**NSLPP MEETING HELD ON 6/12/23**

**ADDRESS:** 173-179 Walker Street, 11, 15 & 17 Hampden Street North Sydney

**APPLICATION No:** 367/22 (PAN 283364)

**PROPOSAL:** Demolition of all buildings and site preparation works, removal of two trees and relocation of a sewer line and install a new sewer connection, and diversion of stormwater infrastructure

PIT TYPE A

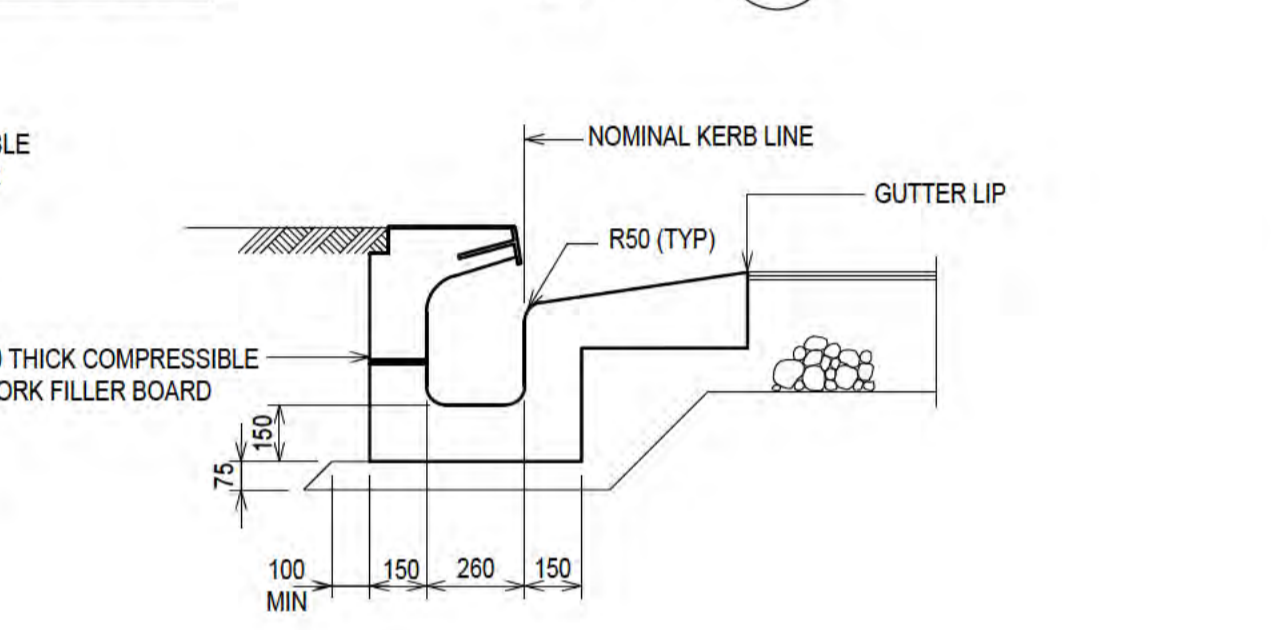
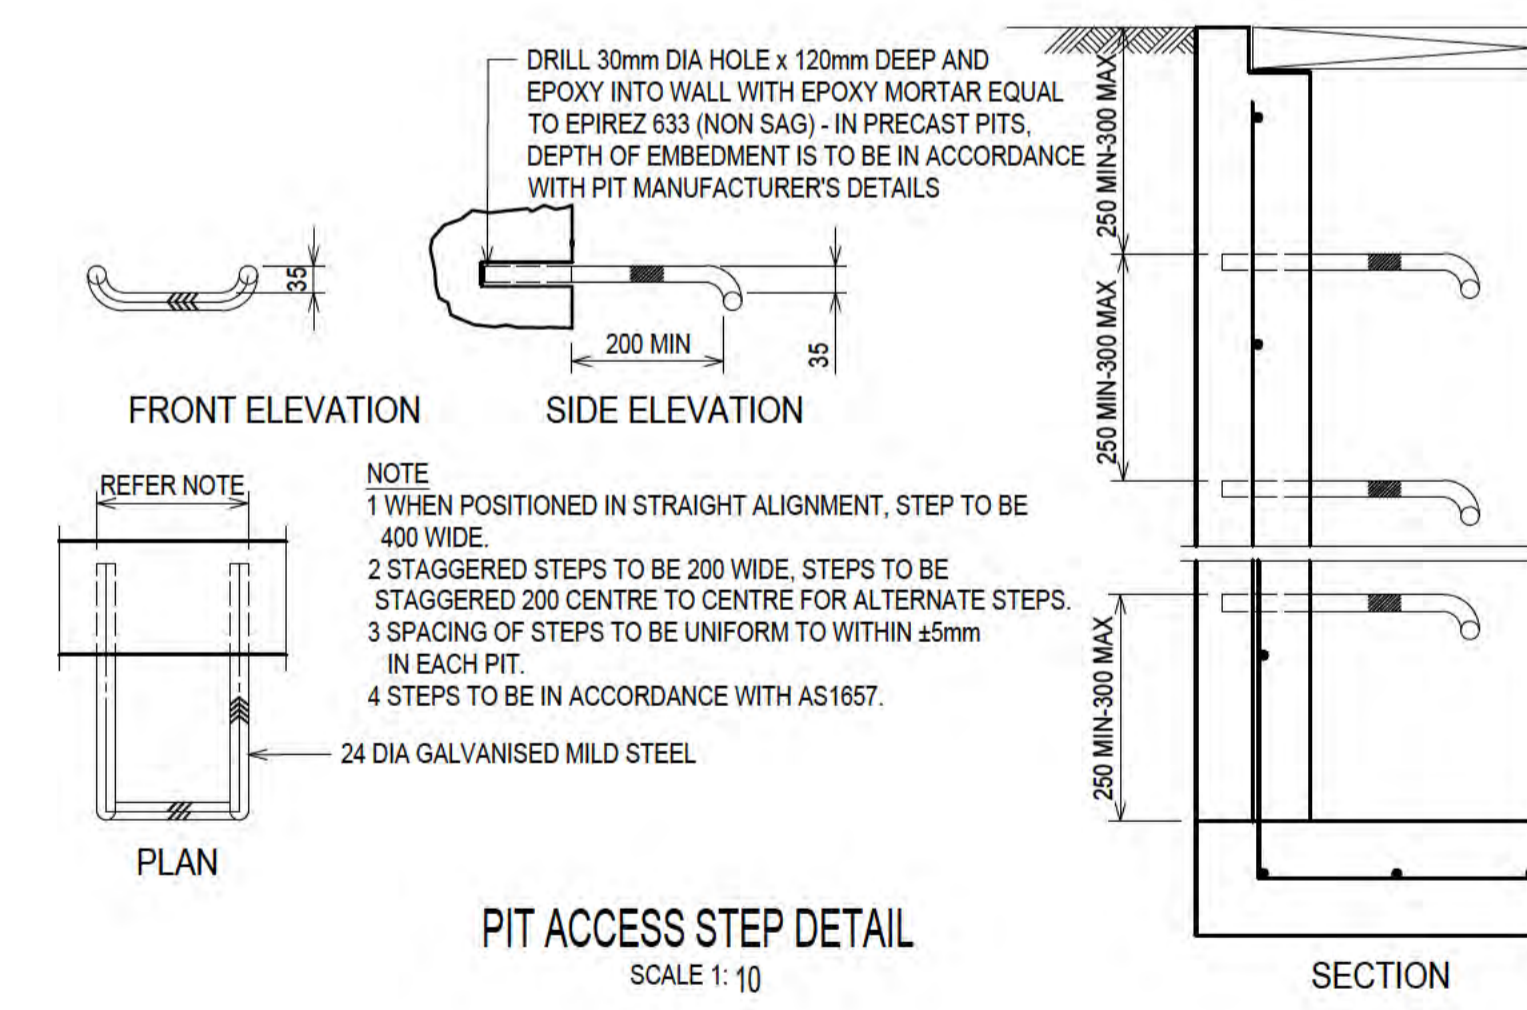
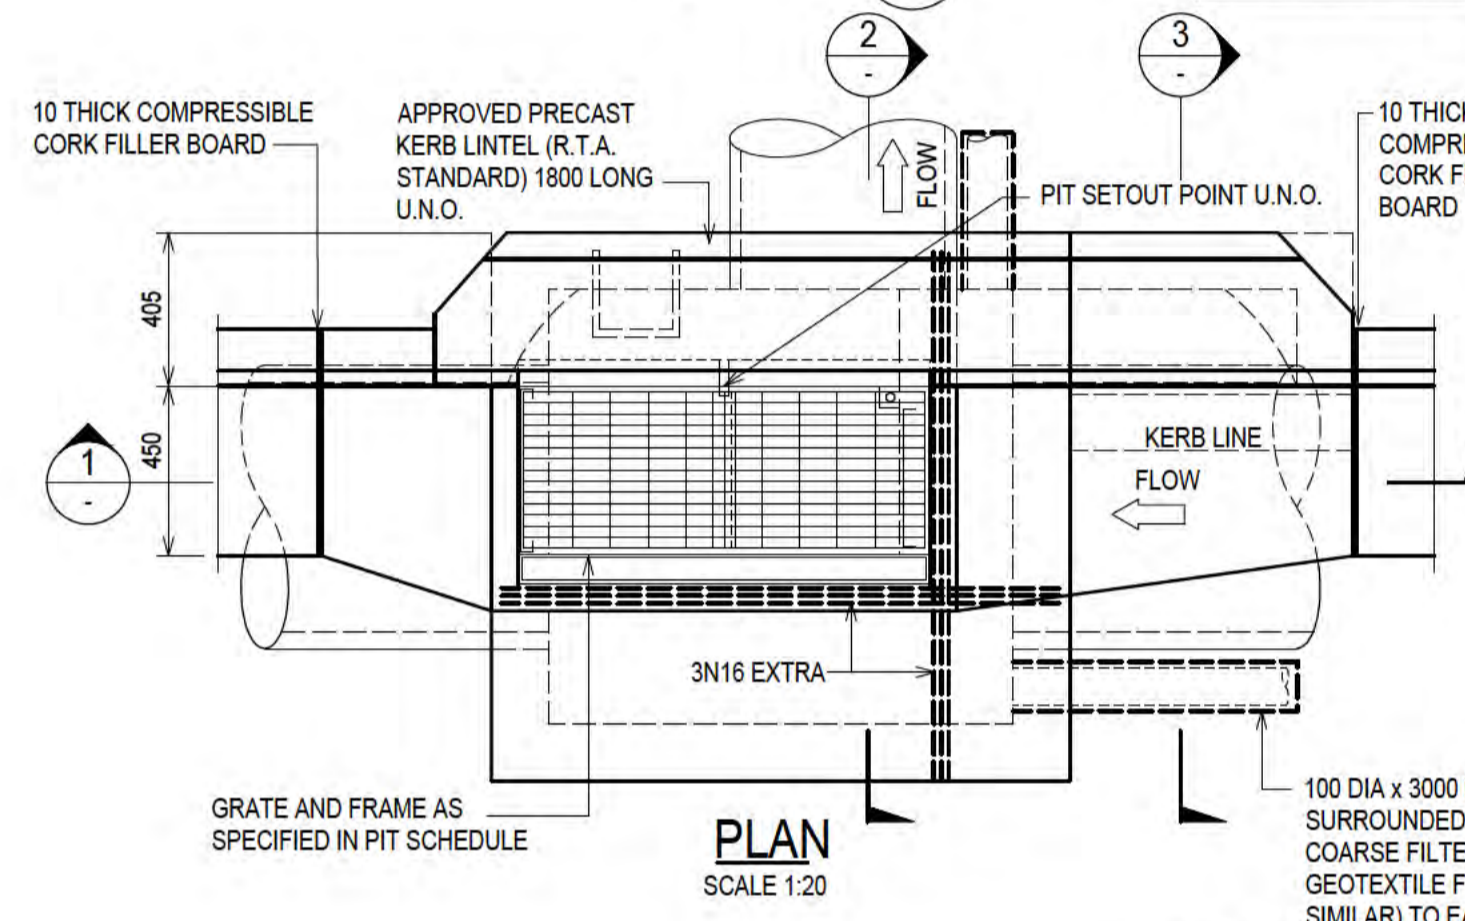
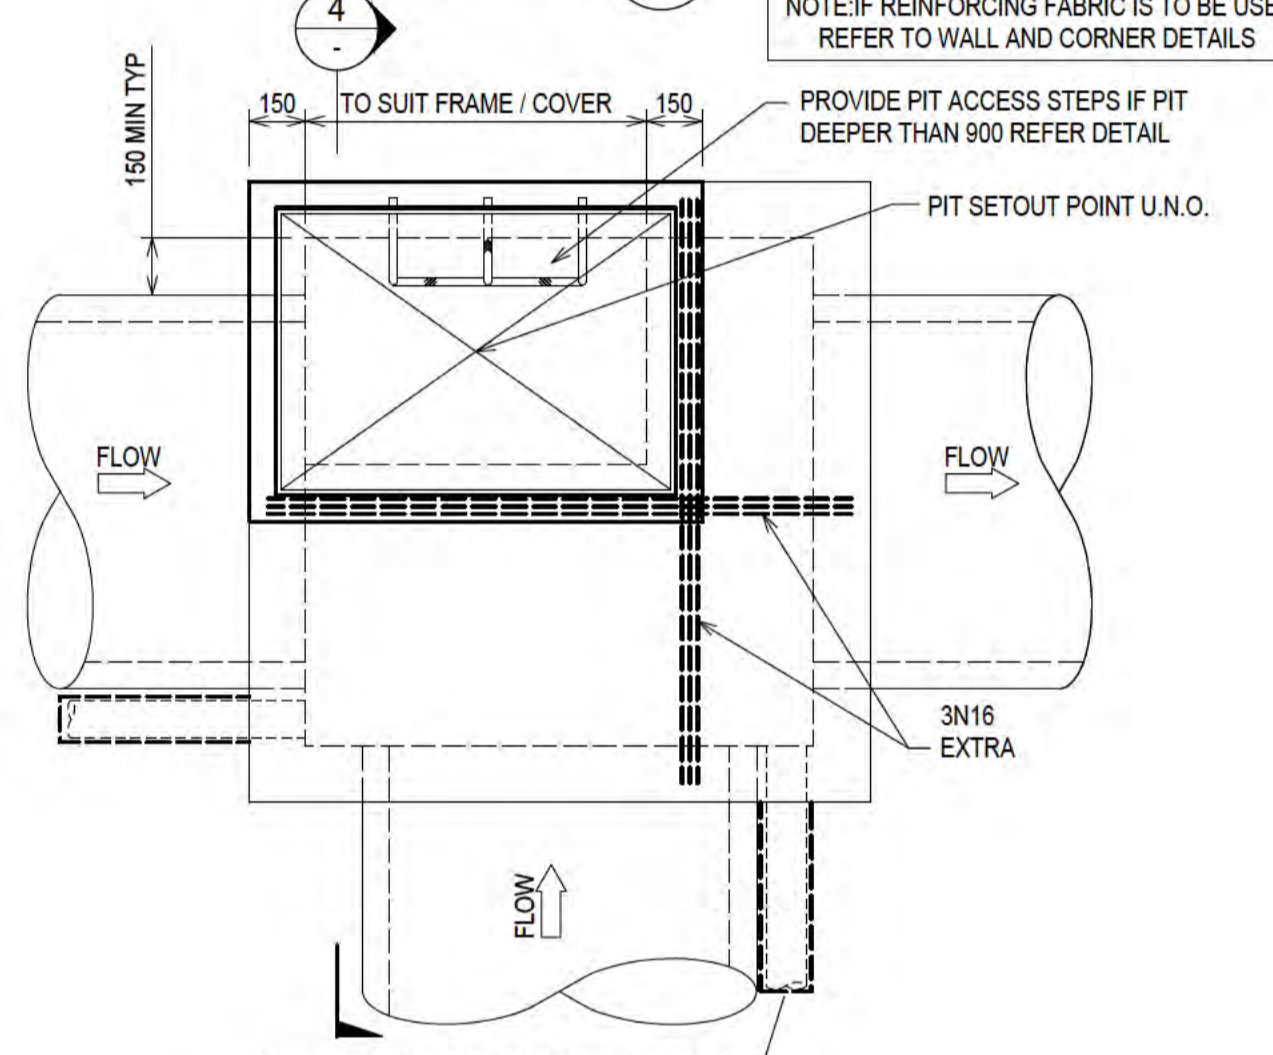
- The new drainage line should be located below new kerb & guttering, not in the middle of the road (Hampden Street).
- A hydraulic grade line is to be added to the drainage long-section to ensure that the drainage has sufficient capacity.
- The final alignment and capacity of the drainage system are to be approved.
- The existing pipe is 5m deep in some locations, pit designs provided are for max 3m deep. Revised pit designs and a pit schedule must be provided for approval.
